HISTORIC AND DESIGN REVIEW COMMISSION

HDRC CASE NO: 2021-397
ADDRESS: 410 AUSTIN ST
LEGAL DESCRIPTION: NCB 517 BLK 11 LOT S 36.2 FT OF 3 & N 11.4 FT OF S 47.6 FT OF W 96 FT OF 3
ZONING: D, H
CITY COUNCIL DIST.: 2
LANDMARK: Robitzsch Brothers Building
APPLICANT: SHIRLEY GERRY & HARMEL OLAF & NEELY JOEL
OWNER: SHIRLEY GERRY & HARMEL OLAF & NEELY JOEL
TYPE OF WORK: Shutter installation
APPLICATION RECEIVED: July 08, 2021
60-DAY REVIEW: Not applicable due to City Council Emergency Orders
CASE MANAGER: Rachel Rettaliata
REQUEST:

The applicant is requesting a Certificate of Appropriateness for approval to replace the existing metal sheeting and burglar bars on the first-floor front façade windows and doors with fully operable wood louvered shutters.

410

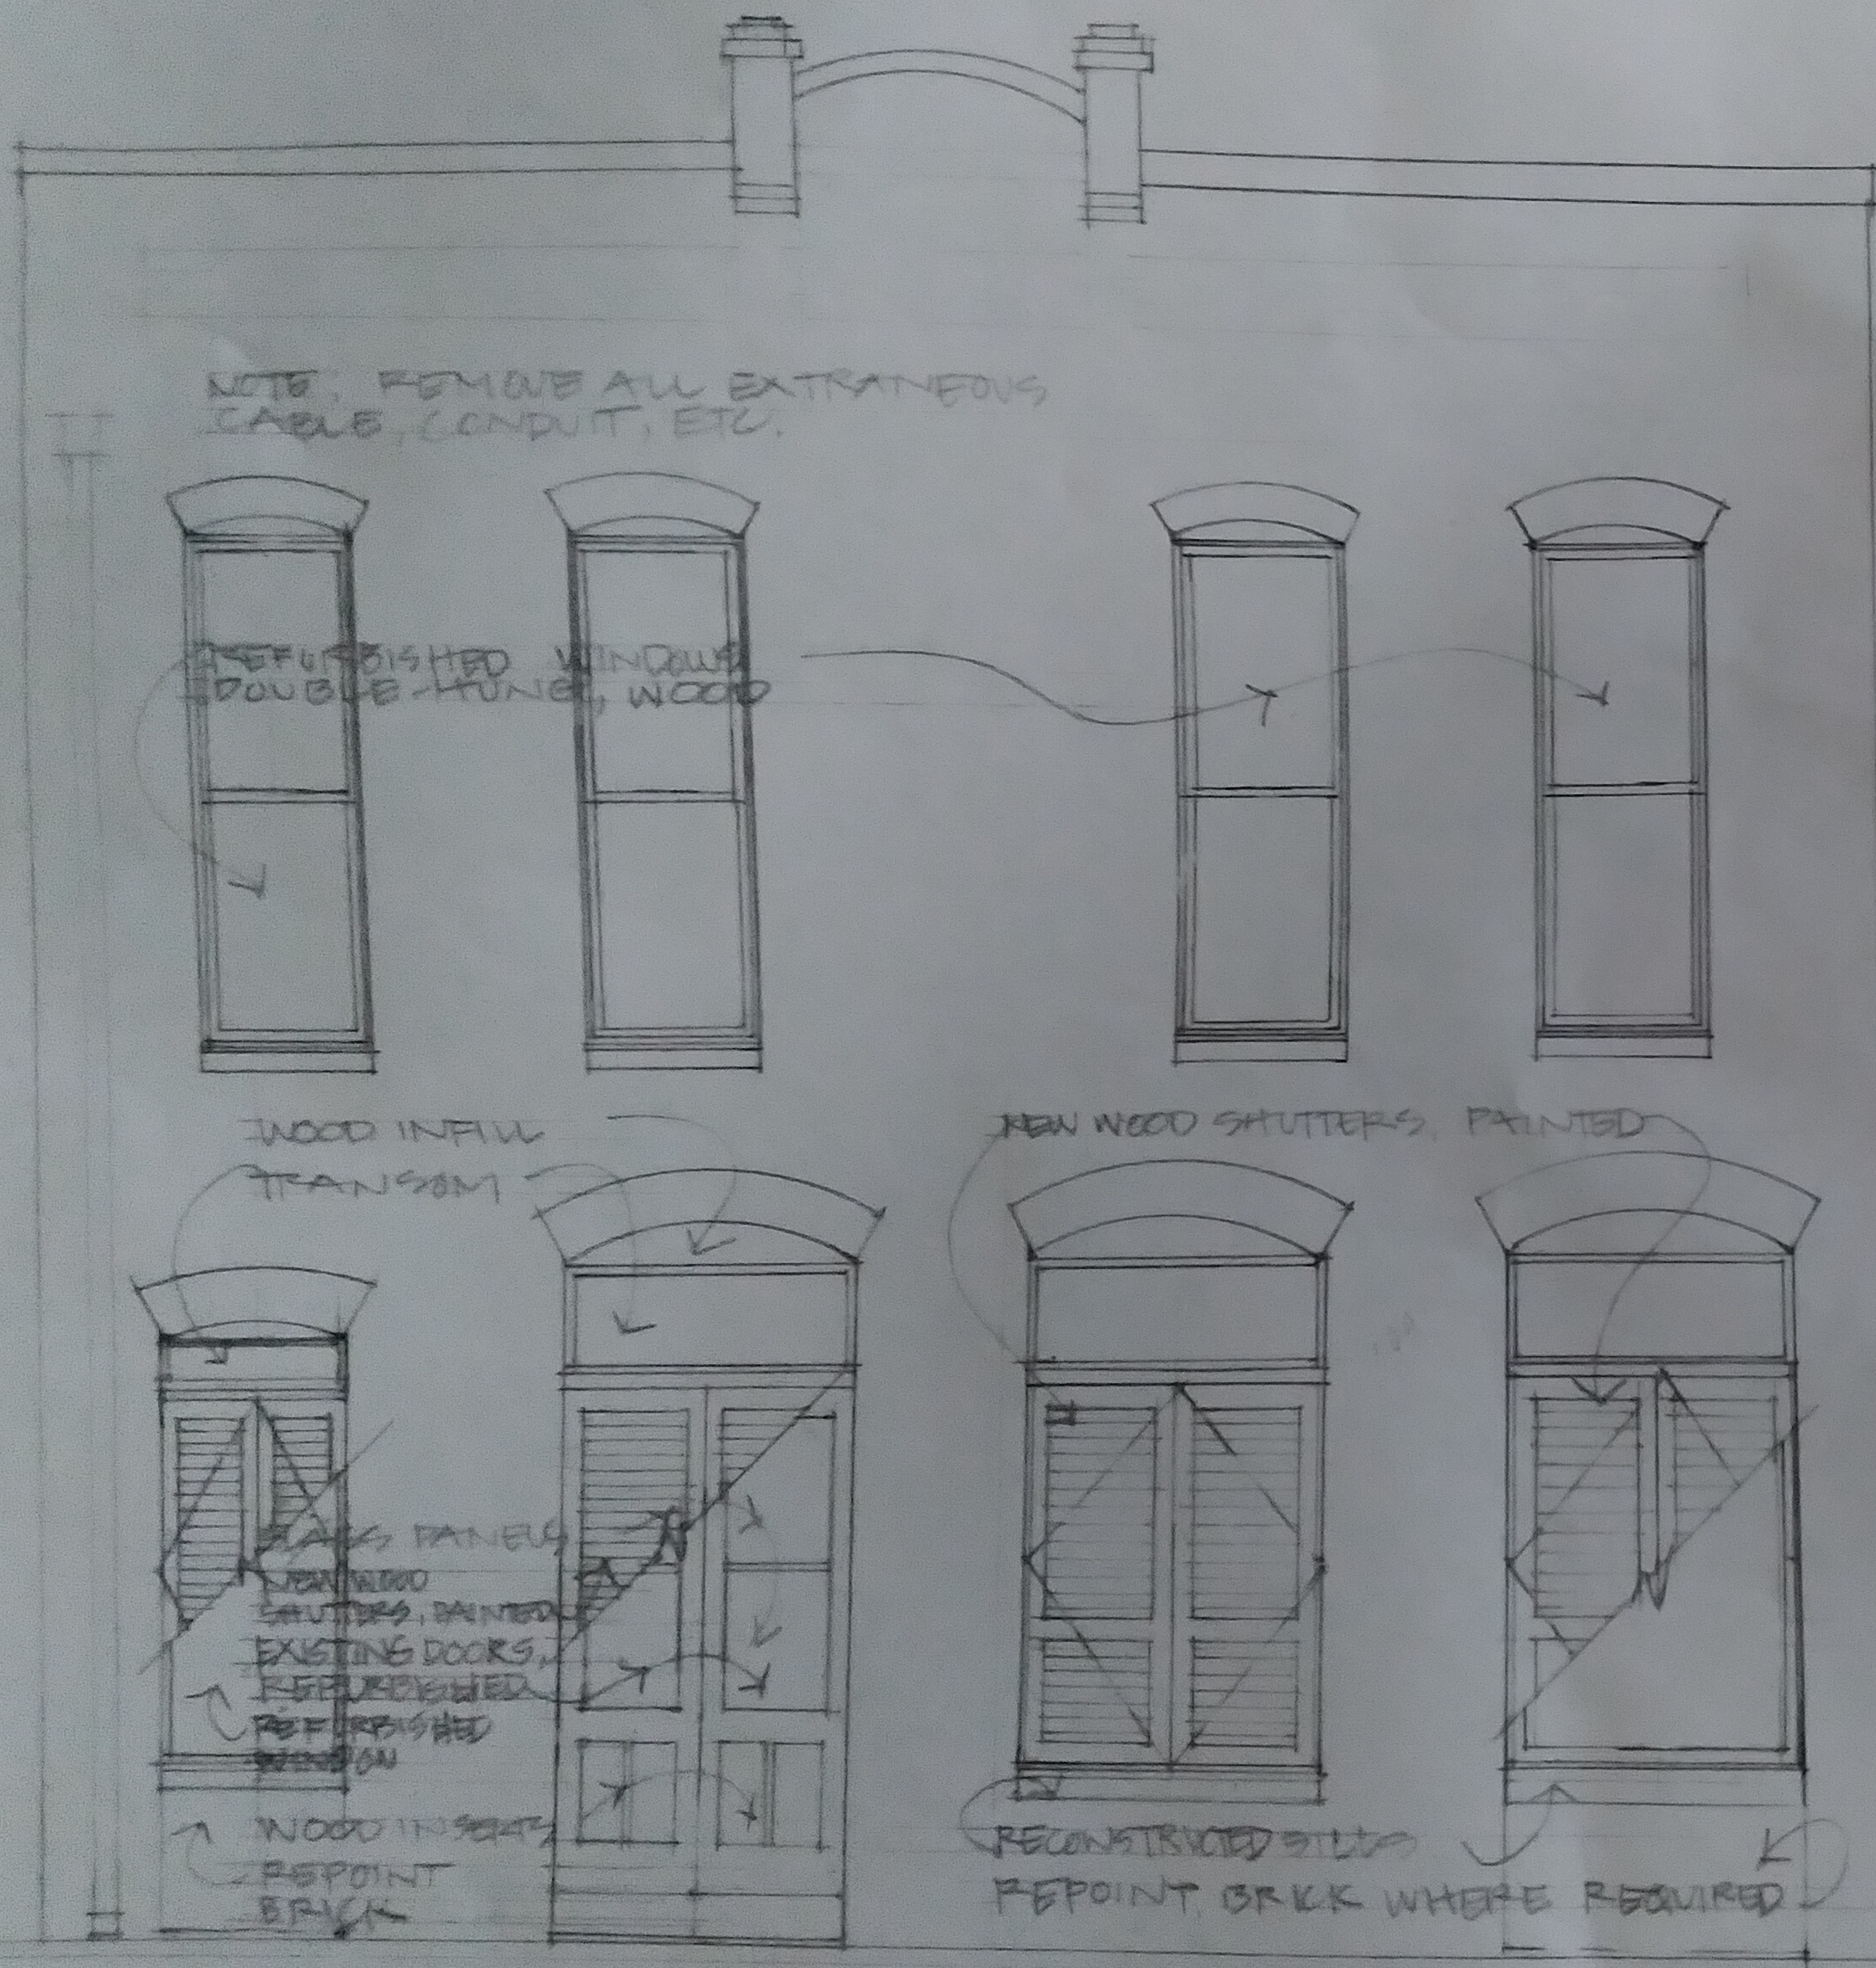
- b. SHUTTER INSTALLATION – The applicant has proposed to install fully operable wood louvered shutters on the first-floor front façade windows and doors. The front façade windows and doors are currently covered with metal sheeting and burglar bars. The applicant has proposed to mount the shutters to the wood door and window framing with stainless steel continuous hinges. Guideline 6.B.x for Exterior Maintenance and Alterations states that shutters should be incorporated only where they existed historically and where appropriate to the architectural style of the structure. Shutters should match the height and width of the opening and be mounted to be operational or appear to be operational. Do not mount shutters directly onto any historic wall material. According to the 1896 and 1904 Sanborn Maps the structure did not historically feature shutters. However, the applicant has proposed to install shutters that match the height and width of the openings. Additionally, the shutters are proposed to be mounted in such a way that they will not impact the historic material. The replacement of the burglar bars and metal sheeting with fully operable wood shutters is an improvement and is a reversible condition. Staff finds the proposal appropriate.

Staff recommends approval of shutter installation based on findings a through b with the following stipulations:

- i. That the sizes of the existing window and door openings are not modified.
- ii. That no historic material be removed to accommodate the installation of the shutters.
